REQUEST FOR INFORMATION	DATE: February 25, 2016	NO.: 6
--------------------------------	--------------------------------	---------------

Project Name: Webster University Interdisciplinary Science Building Project No.: 15051

Subject: Proposal to lower sanitary line

SANITARY SYSTEM 1 PROFILE

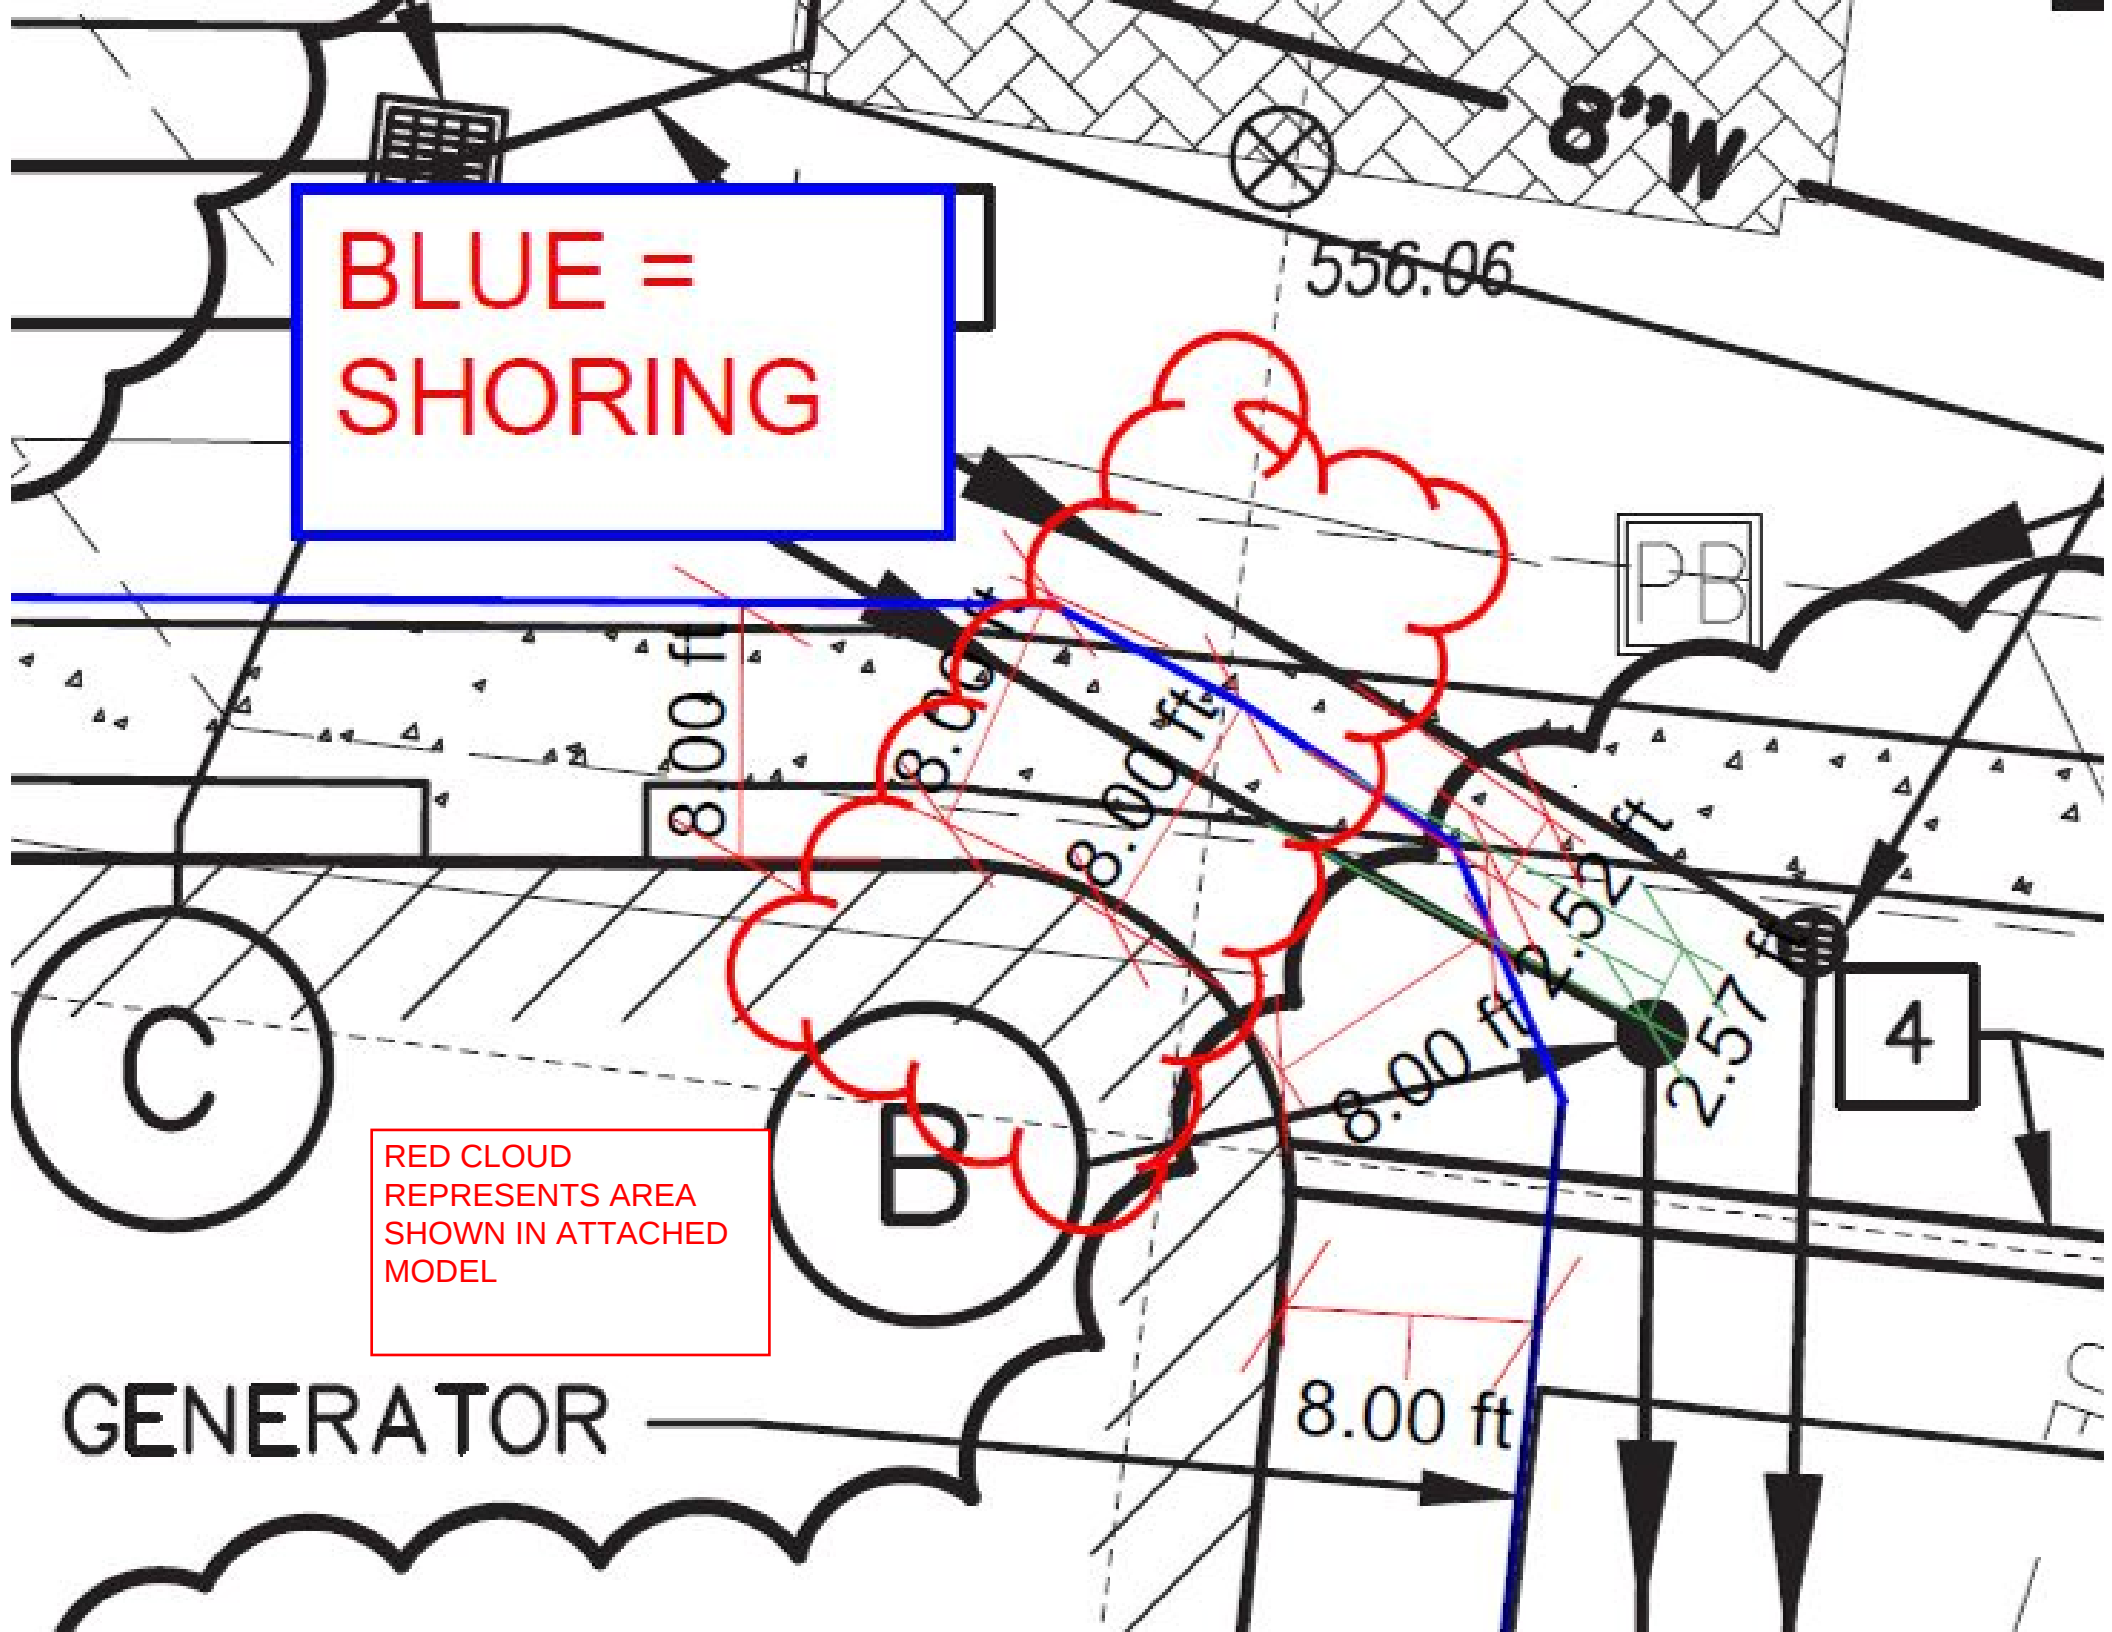
Please see attached sketches. In the RFI # 5 response to question number 6 we were told the lines cannot be moved to the north due to the existing duct bank. This will still cause a constructability issue due to the elevation.

Suggestion: Paric proposes to lower the top of the sanitary pipe below 541' at the corner of the building (as shown) to avoid this conflict.

Paric's proposed lowering of sanitary pipe is acceptable. Sewer profile drawing will be revised (see attached) for MSD submittal / approval. Note the final approval is contingent on MSD approval."
